**KAWARTHA PINE RIDGE DISTRICT SCHOOL BOARD
PUR24-072-ITT
Hampton Junior Public school Classroom Refresh**

ADDENDUM NO. 2

Add (3): Addendum No. 1, Project 24004, prepared by Barry Bryan Associates, (4 pages)

Project No.: 24004
Date: April 24, 2024
Tender No.: PUR24-072-ITT
Project: **KAWARTHA PINE RIDGE DISTRICT SCHOOL BOARD
Classroom Refresh at Hampton Jr. Public School**

DATE: SEPT. 1971 SCALE: AS NOTED	CHECKED: GNC PROJECT NO.: 7105	DRAWING NO.: DS-1
	JOHN LAYNG ARCHITECT TORONTO ONTARIO L.A. PARKER & ASSOCIATES LTD. CONSULTING ENGINEERS 121 CAVAN STREET PORT HOPE, ONT.

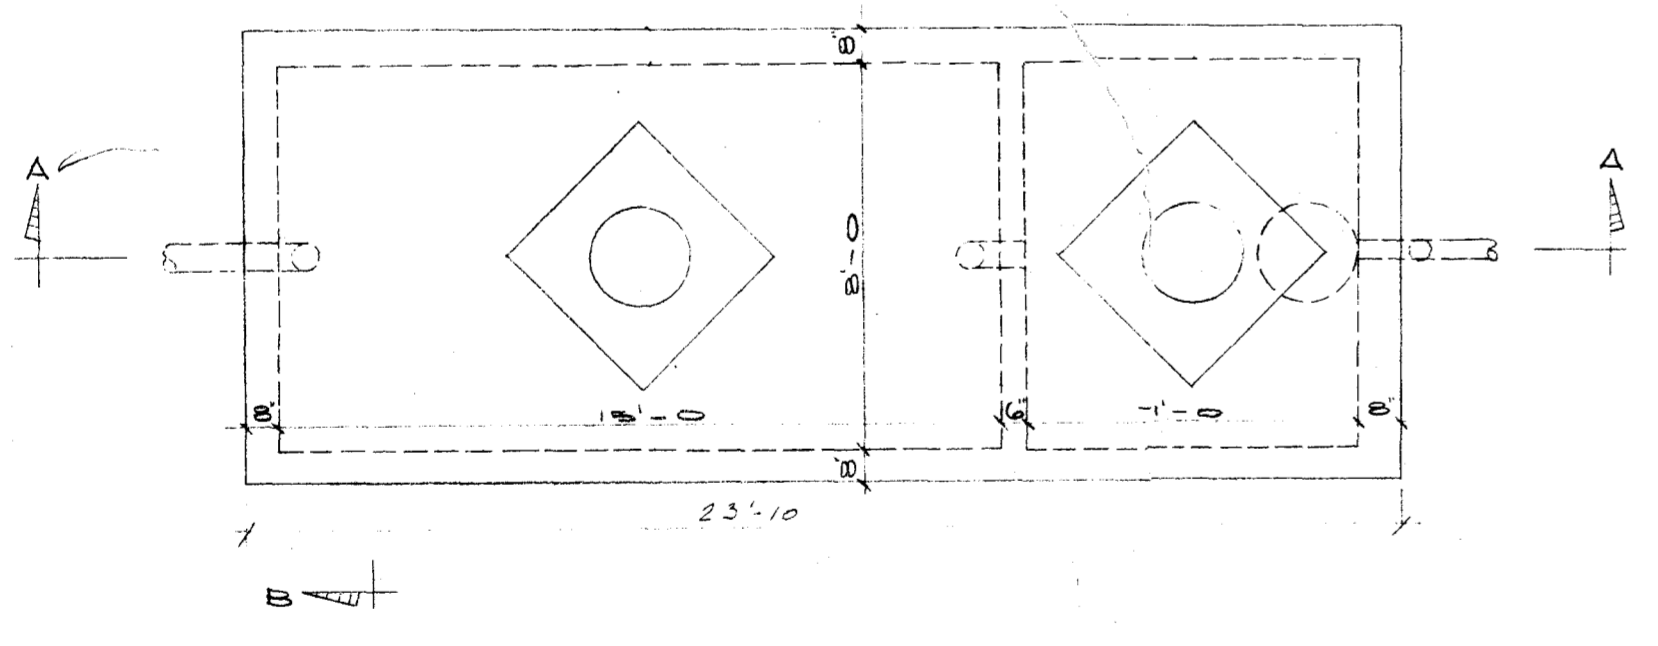
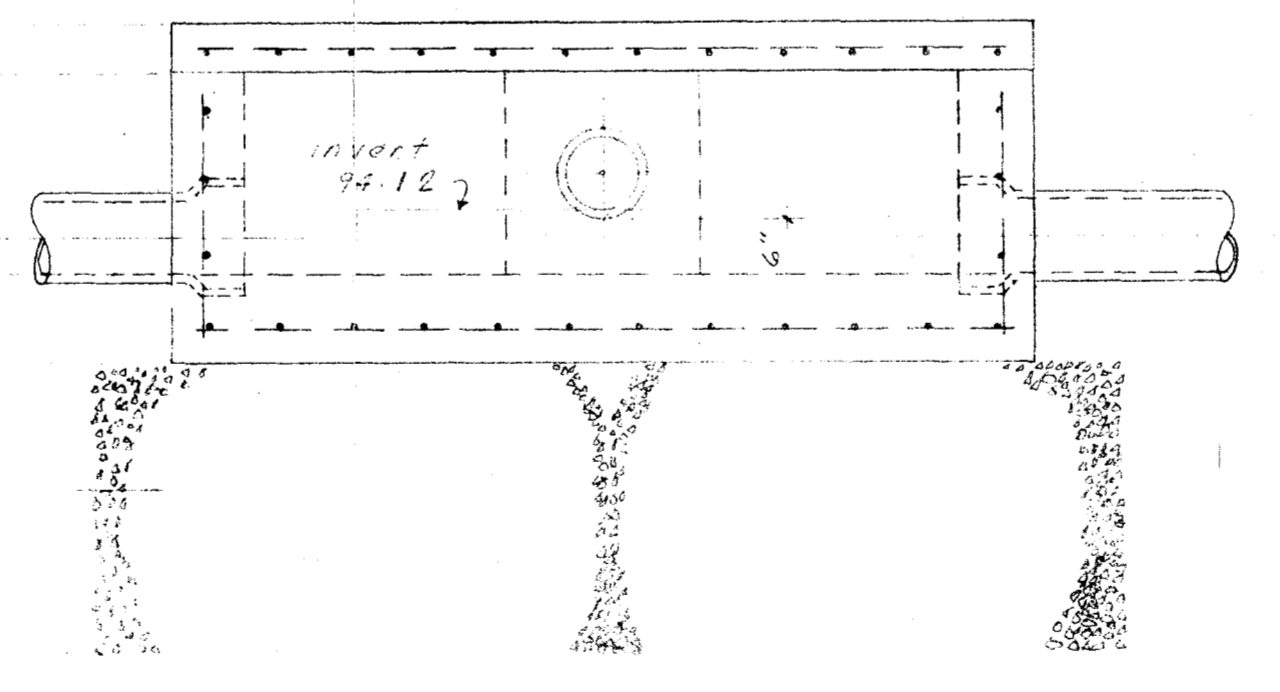
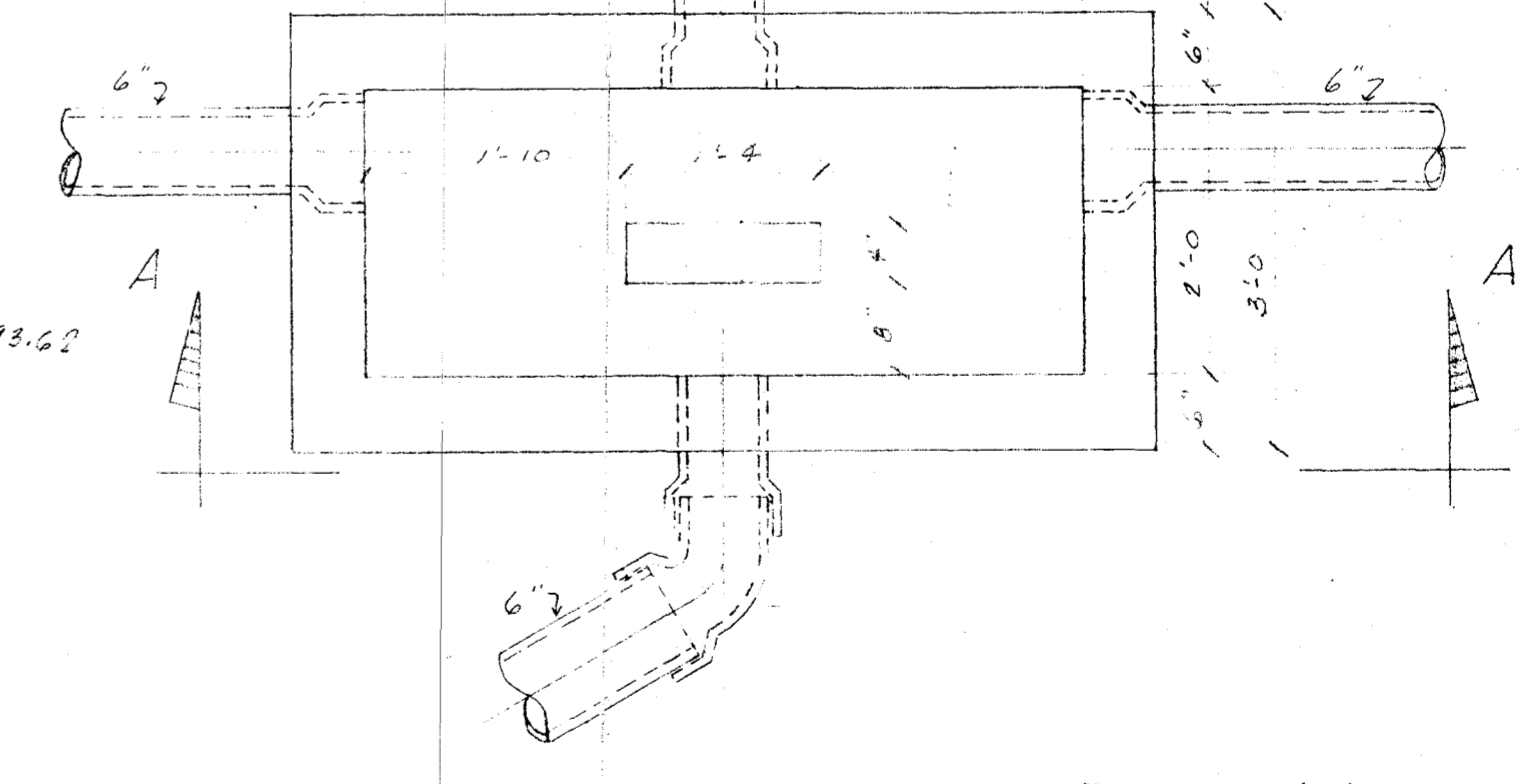
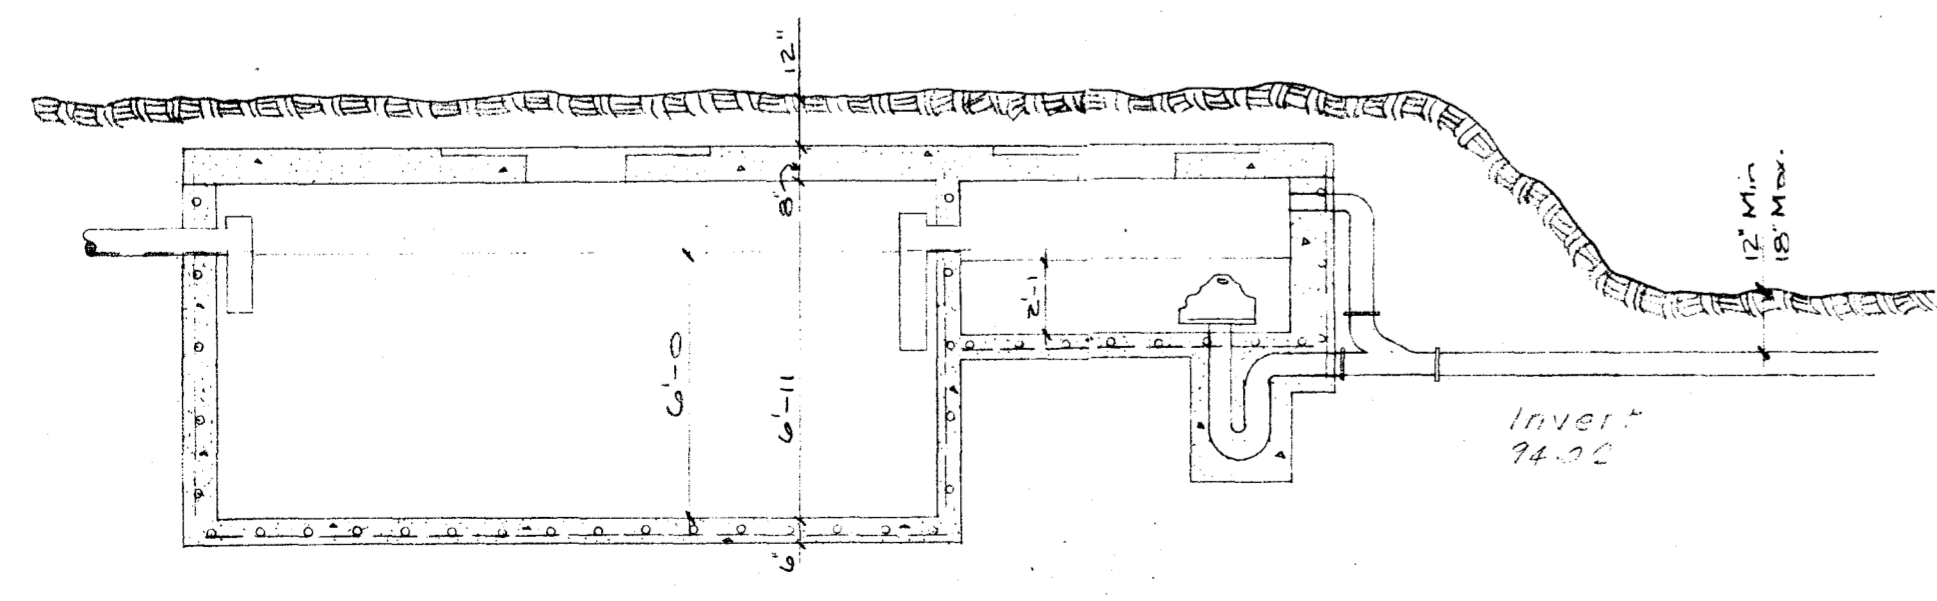
1.9 **Question:** Provide approximate invert depth of the existing sanitary pipe at connection points.

Answer: Please refer to the attached existing reference material DS-1 Existing and Proposed New Field Tile Disposal System.
